Project	<b>IEEE 802.16 Broadband Wireless Access Working Group</b> < <a href="http://ieee802.org/16">http://ieee802.org/16</a> >
Title	<b>Legacy Support Modes in D2 (15.3.3.5)</b>
Date Submitted	<b>2009-11-06</b>
Source(s)	Mark Cudak, Fred Vook, Bill Hillery, Anup Talukdar and Eugene Visotsky Motorola <a href="mailto:mark.cudak@motorola.com">mark.cudak@motorola.com</a>
Re:	Category: P802.16m/D2 comments for LB30a Area: Chapter 15.3.3.5 (Frame structure supporting WirelessMAN-OFDMA)
Abstract	The current backward compatibility modes in D2 do not meet the requirements for legacy support defined in the SRD. The document proposes changes to the frame structure to meet the goals of the SRD.
Purpose	Discuss and adopt
Notice	<i>This document does not represent the agreed views of the IEEE 802.16 Working Group or any of its subgroups. It represents only the views of the participants listed in the "Source(s)" field above. It is offered as a basis for discussion. It is not binding on the contributor(s), who reserve(s) the right to add, amend or withdraw material contained herein.</i>

## Legacy Support Modes in D2 (15.3.3.5)

Figure 478—TDD frame configuration for supporting the WirelessMAN-OFDMA operation with UL FDM

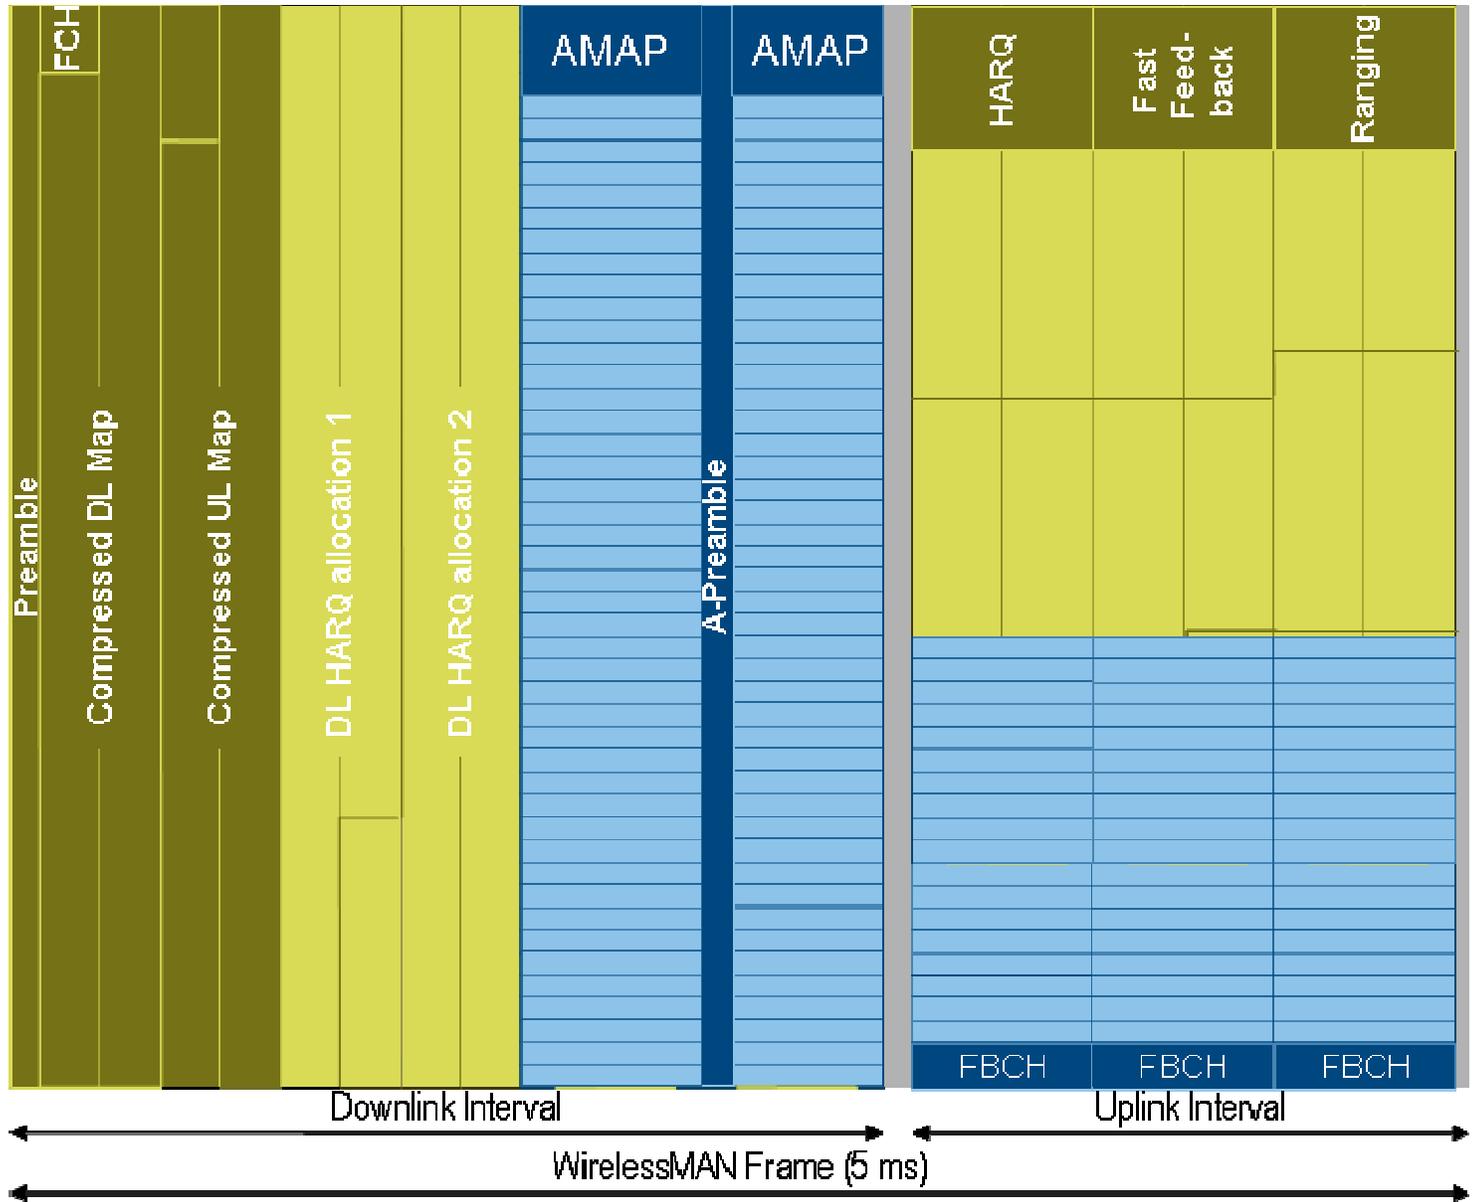
The WirelessMAN-OFDMA and the Advanced Air Interface frames shall be offset by a fixed number of subframes,  $FRAME\_OFFSET = 1, 2, \dots, K$  as shown in Figure 478 and Figure 479. The  $FRAME\_OFFSET$  of different ABSs shall be the same within the same deployment region. When the Advanced Air Interface frames support the WirelessMAN-OFDMA for 5, 10, 20 MHz channel bandwidths, all subframes in the Advanced Air Interface DL Zone are type-1 subframes. The number of symbols in the WirelessMAN-OFDMA DL Zone is  $5+6 \cdot (FRAME\_OFFSET-1)$ . When the Advanced Air Interface frames support the WirelessMAN-OFDMA for the 8.75 MHz channel bandwidth with 15 UL OFDM symbols and for the 7 MHz channel bandwidth with 12 UL OFDM symbols, all subframes in the Advanced Air Interface DL Zone are type-1 subframe. The number of symbols in the WirelessMAN-OFDMA DL Zone is  $3+6 \cdot (FRAME\_OFFSET - 1)$  for 8.75 MHz and  $9+6 \cdot (FRAME\_OFFSET - 1)$  for 7 MHz. The maximum value of parameter K is equal to the number of DL subframes minus two

The offset K is determined by the TDD ratio of the Advanced Air Interface frame. For example, a TDD ratio of 4:4 with 4 downlink subframes and two uplink subframes shall have a  $FRAME\_OFFSET$  of 5. Similarly, a TDD ratio of 5:3 shall have a  $FRAME\_OFFSET$  of 5. At minimum, one Advanced Air Interface subframe shall exist carrying the Advanced Air Interface subframe. Additional subframes may precede the subframe carrying the Advanced Air Interface subframe if additional capacity is required.

<Replace Figure 478 with the following>
